Southern Shrimp Alliance

April 21, 2023

RE: Proposed Sale Notice for Commercial Leasing for Wind Power Development on the

Outer Continental Shelf in the Gulf of Mexico, BOEM 2023-0021, 88 FR 11939, February

Figure 1:

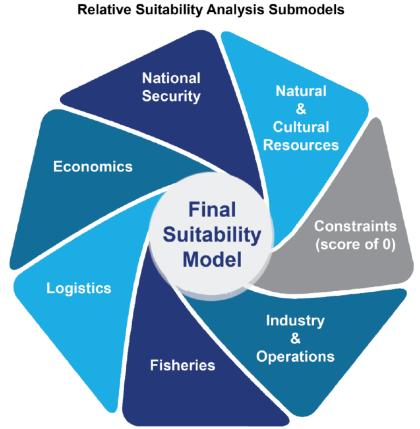
MEXICO CALL AREA",² areas included in that Constraints Submodel, such as areas with moderate-to-high shrimp fishing effort, were assigned a suitability score of zero. (see Figure 1)

Lease Area OCS-G 37334

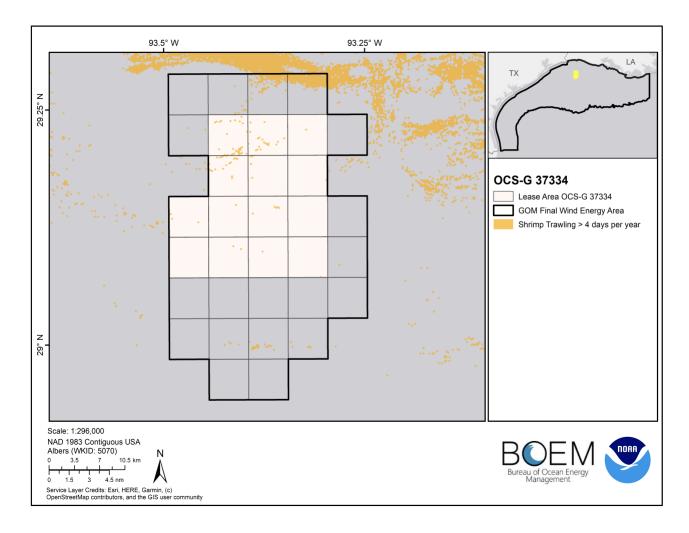
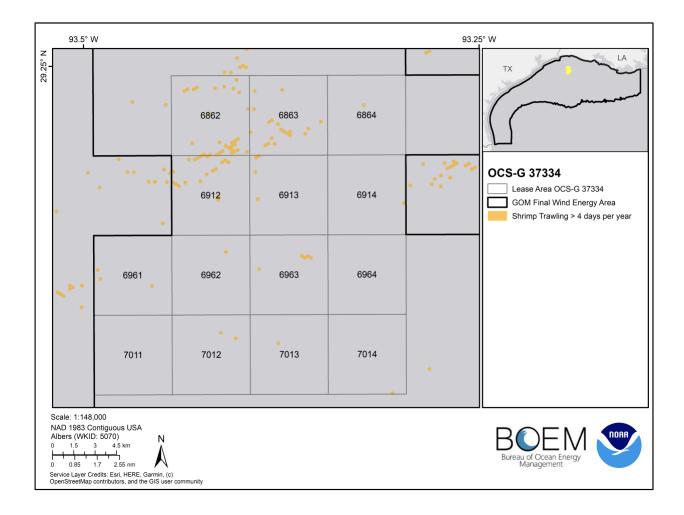
SSA **requests** BOEM's consideration and implementation of either one of the two following options to modify this proposed Lease Area.

Option 1: Remove the following three OCS lease blocks from this Lease Area: 6862, 6863, 6912. These OCS lease blocks each contain significant quantities of moderate-to-high shrimp fishing effort. This Option 1 would achieve the objective to more fully deconflict OSW facility siting with the shrimp industry.

Option 2: Shift the entire proposed Lease Area in a southward direction by one OCS lease block, and remove OCS lease block 6912, so that the northernmost row of OCS lease blocks in this proposed lease area would be: 6913 and 6914. This Option 2 would have the effect of removing those 3 OCS lease blocks 6862, 6863 and 6912 that contain areas with significant moderate-to-high shrimp fishing effort from this proposed Lease Area and would achieve the objective to more fully deconflict OSW facility siting with the shrimp industry. This Option 2 would also have the effect of maintaining nearly the same size of this proposed Lease Area with the net loss of only one OCS lease block (7.1%) from the total proposed Lease Area of 14 OCS lease blocks.

Lease Area OCS-G 37335

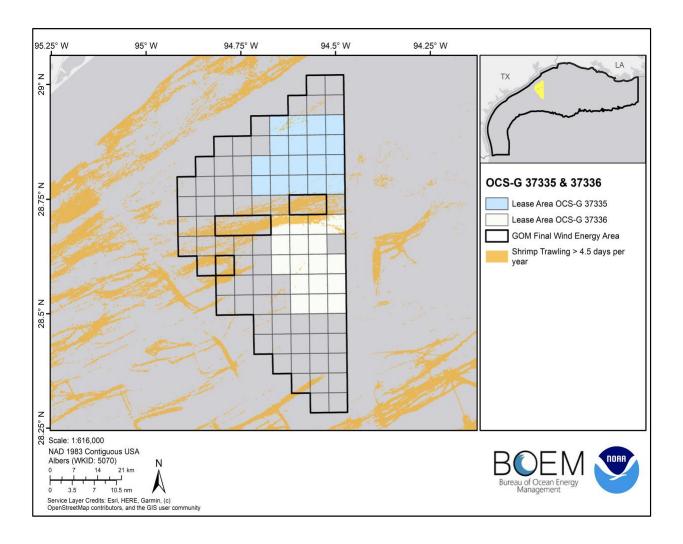
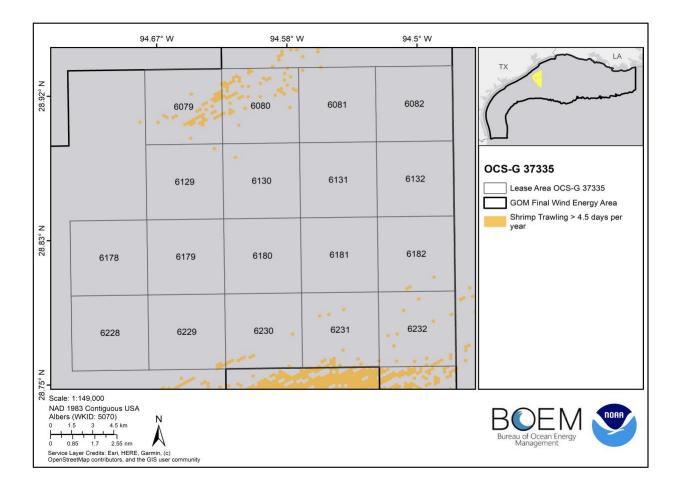
SSA **requests** BOEM's consideration and implementation of the following modification to this proposed Lease Area.

Remove the following two OCS lease blocks from the proposed Lease Area: 6079, 6080. These OCS lease blocks each contain significant quantities of moderate-to-high shrimp fishing effort. This would achieve the objective to more fully deconflict OSW facility siting with the shrimp industry. This would also have the effect of limiting the reduction in the size of the proposed Lease Area with the net loss of only two OCS lease blocks (11.1%) from the total proposed Lease Area of 18 OCS lease blocks.
